MEMORANDUM

TO: Cassie Younger, Maverik, Inc.
FROM: Stacey Nerger, Senior Planner
DATE: January 3, 2022
SUBJECT: SP21-133 Lincoln Professional Park Filing No. 1 Lot 1 Site Plan

MAVERIK INC. STORE
 LINCOLN AVE. AND DRANSFELDT RD.
 PARKER, CO

1 SITE PHOTOMETRIC PLAN
E-1.2 SCALE: 1"=30'-0"

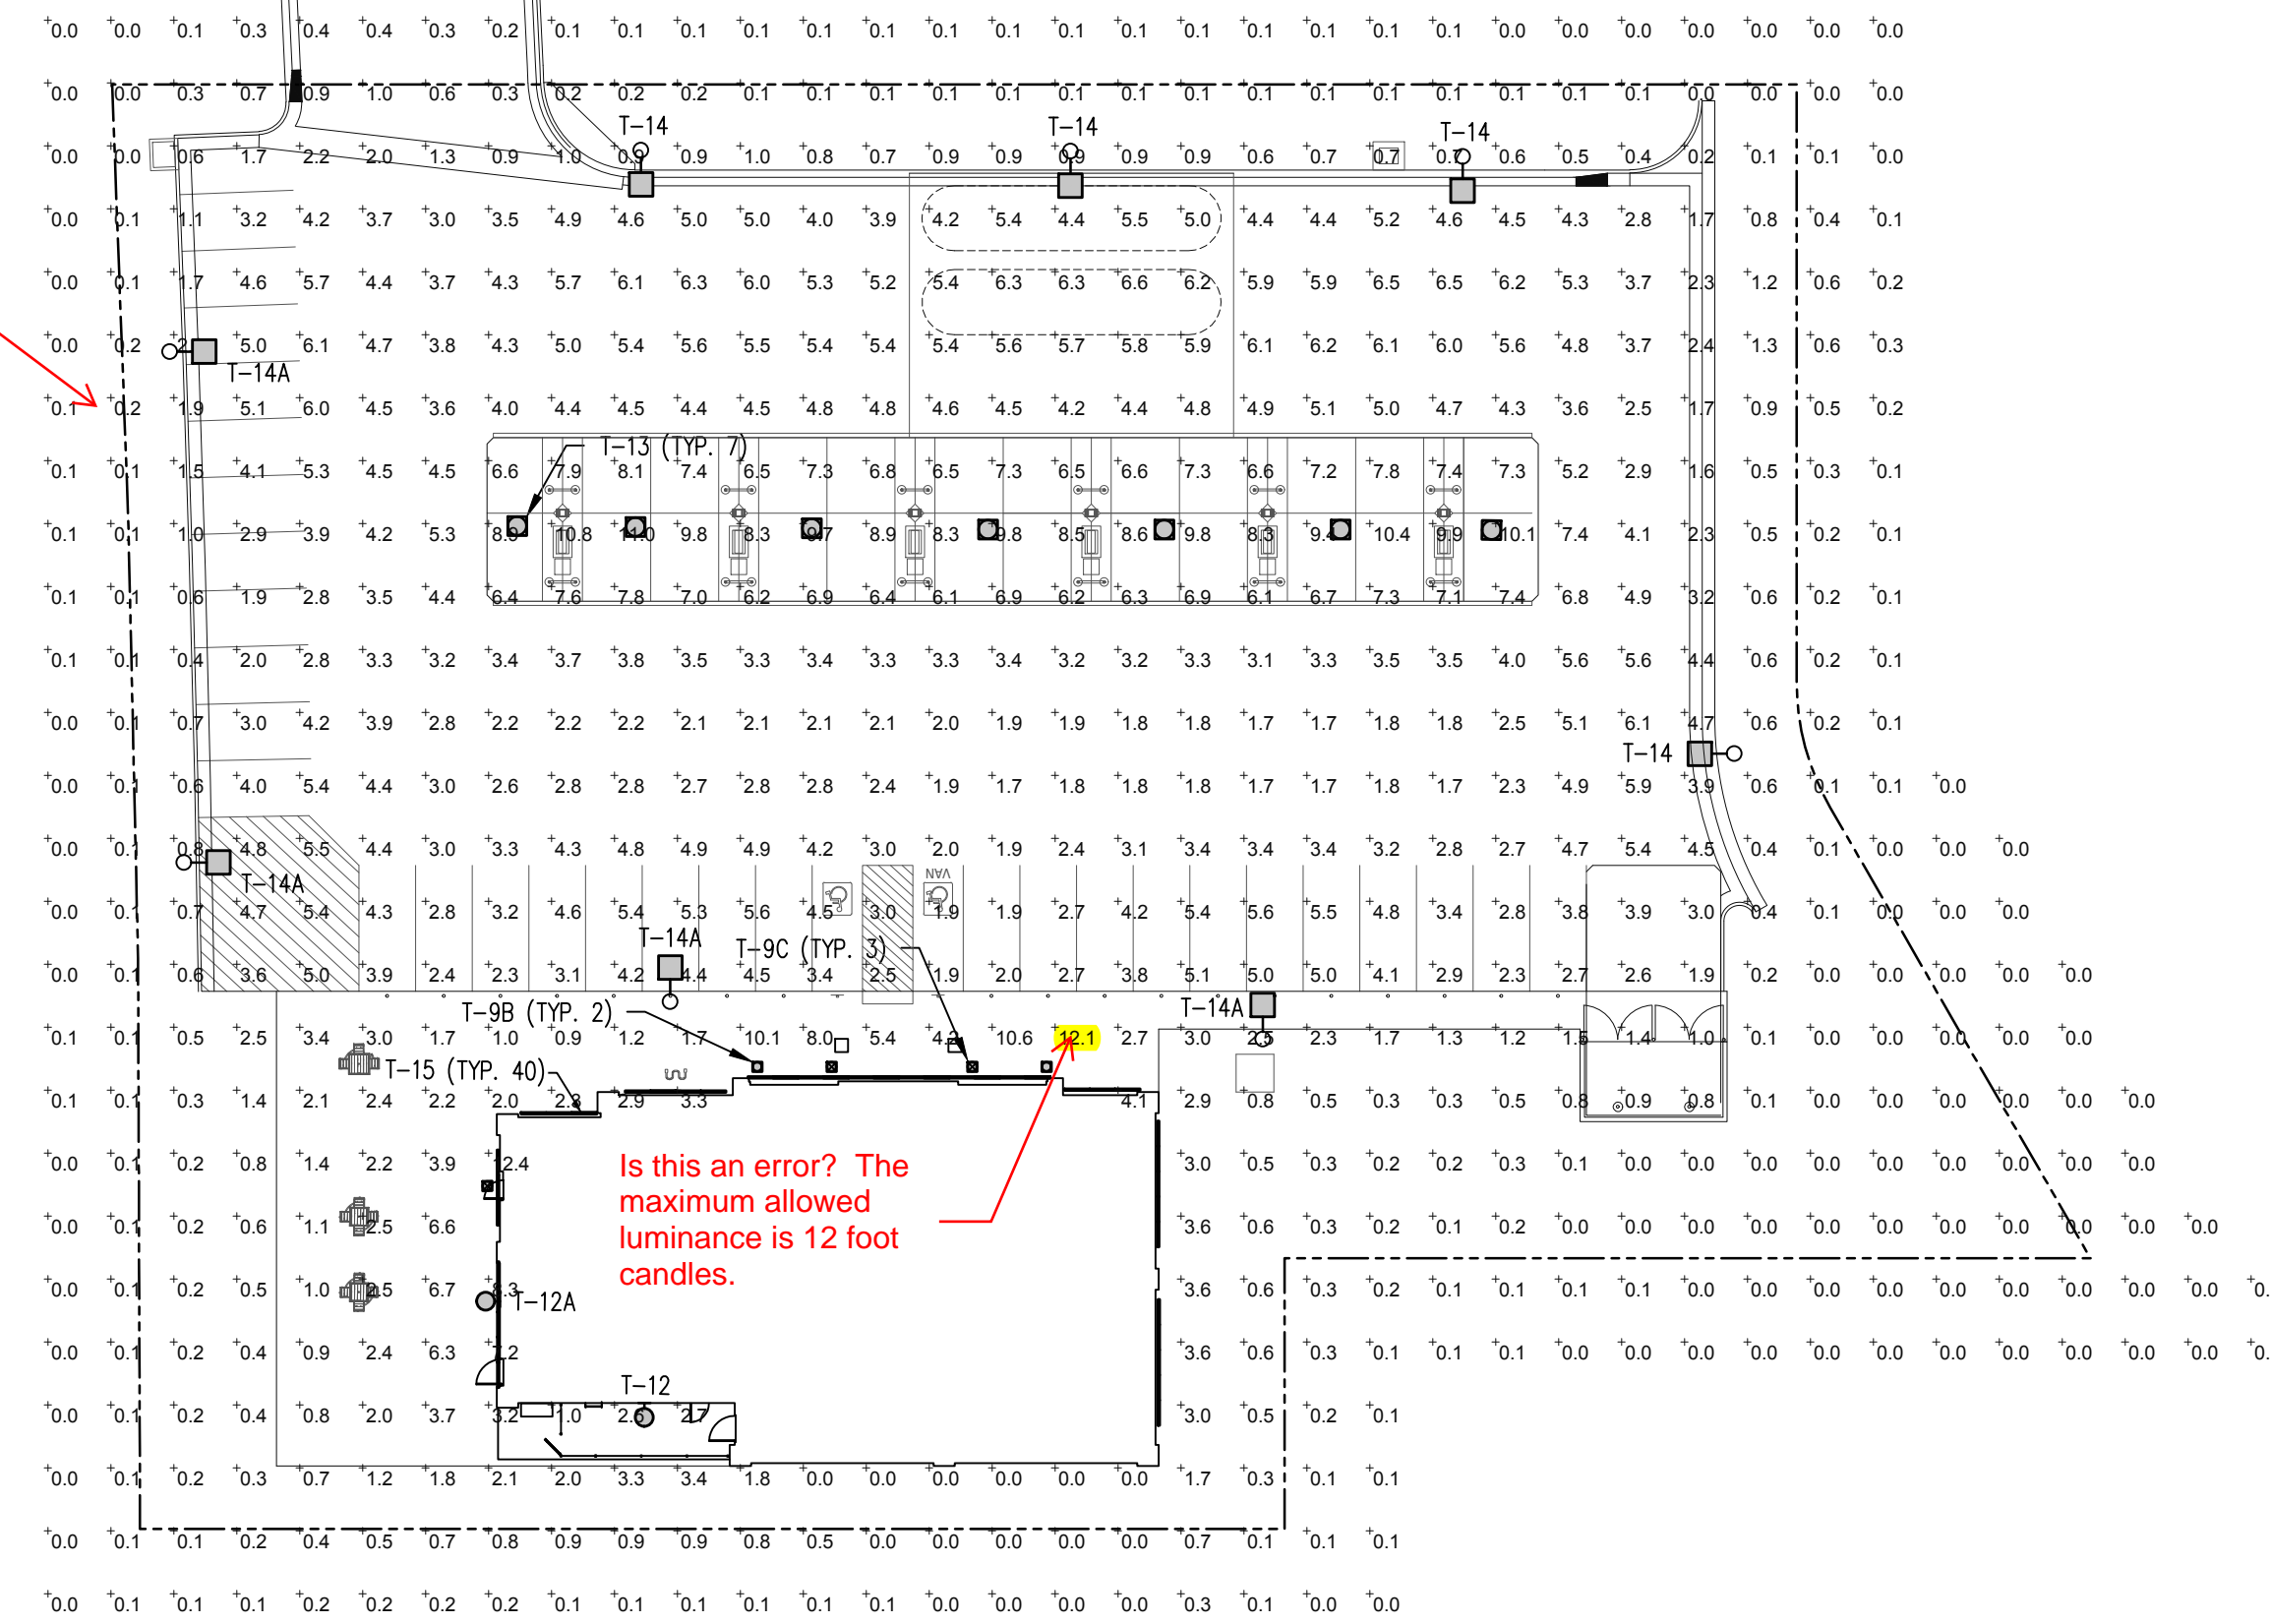
Change this column to be the color of the luminaire.

Can this be made larger on this page for easier reading.

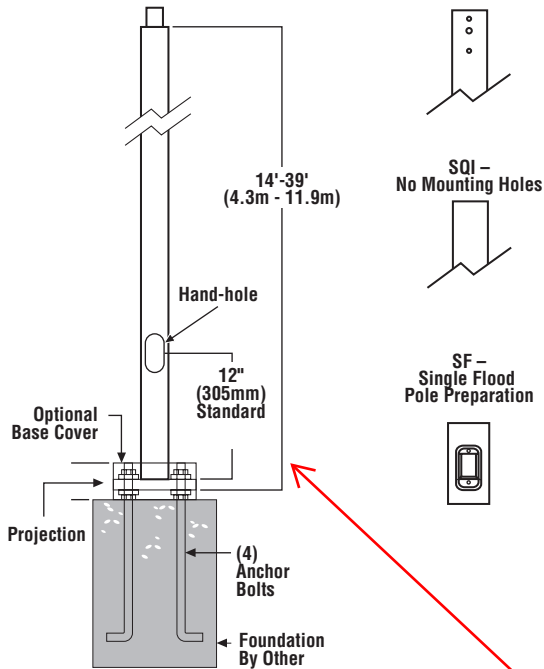
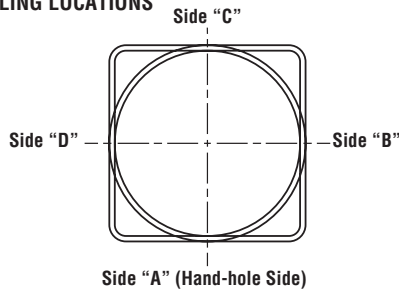
Please ensure that this information and height is included on the photometric plan and matches the information within the table.

2 RIGHT ELEVATION
SCALE: 1/4" = 1'-0"

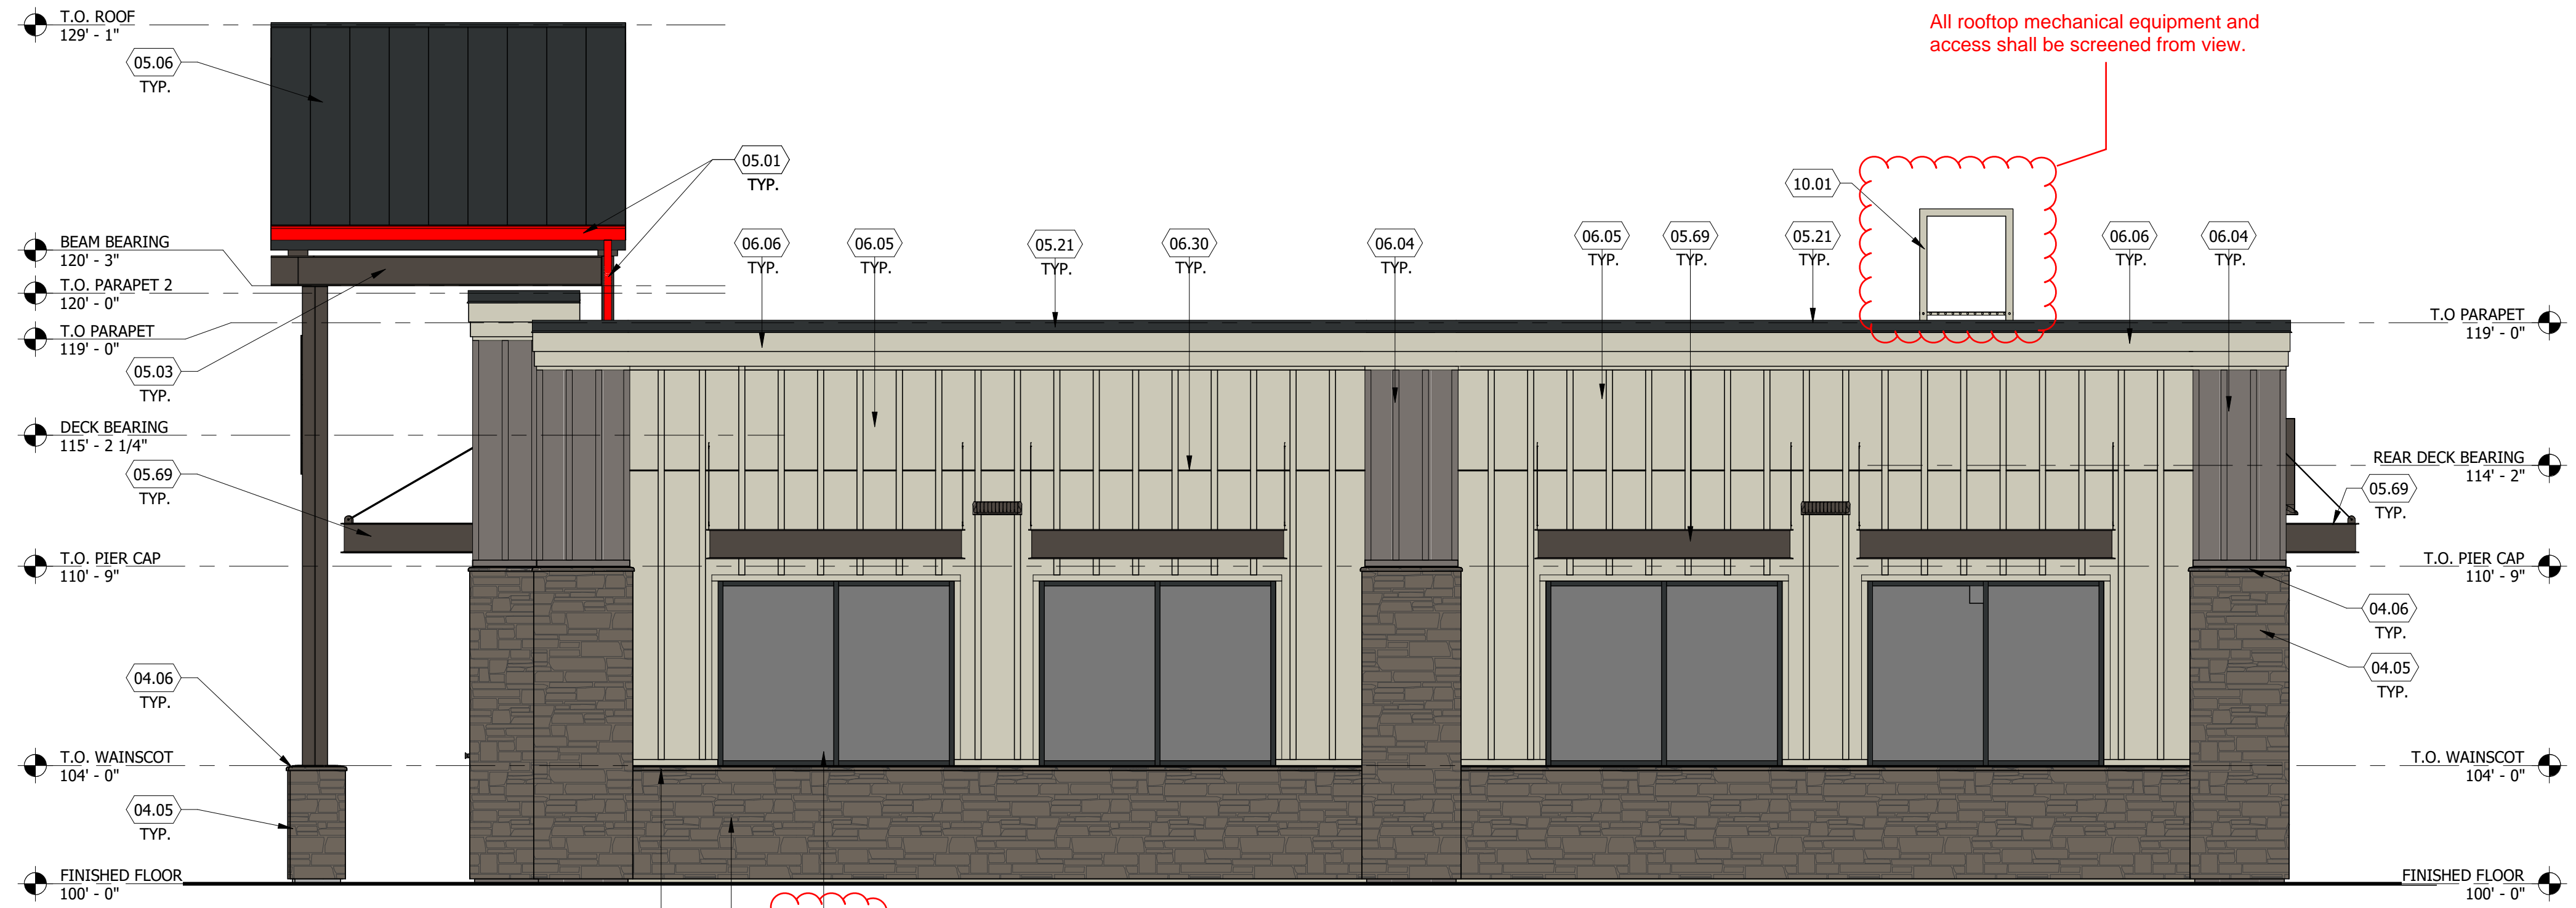
Please remove the word "vener"

Please change this to north.

Please explain what these are in more detail. Are these real windows or metal?

1 REAR ELEVATION
SCALE: 1/4" = 1'-0"

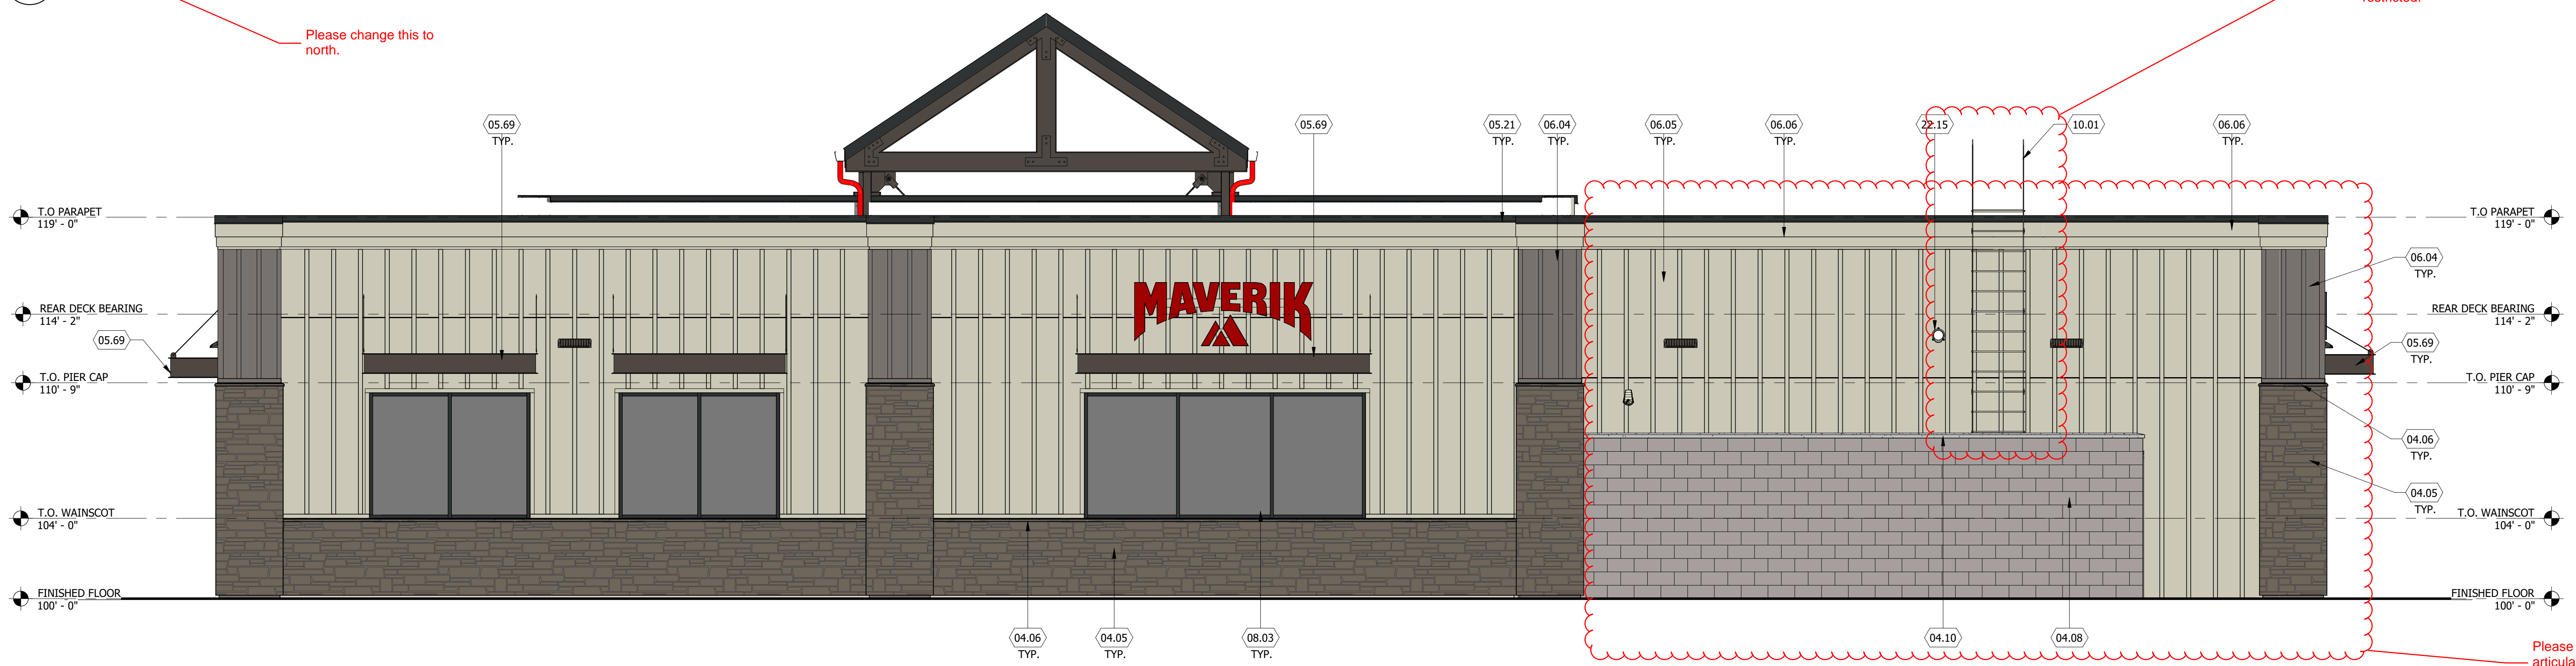
All rooftop access should be provided interior to the site. Exterior access is restricted.

Please change this to west.
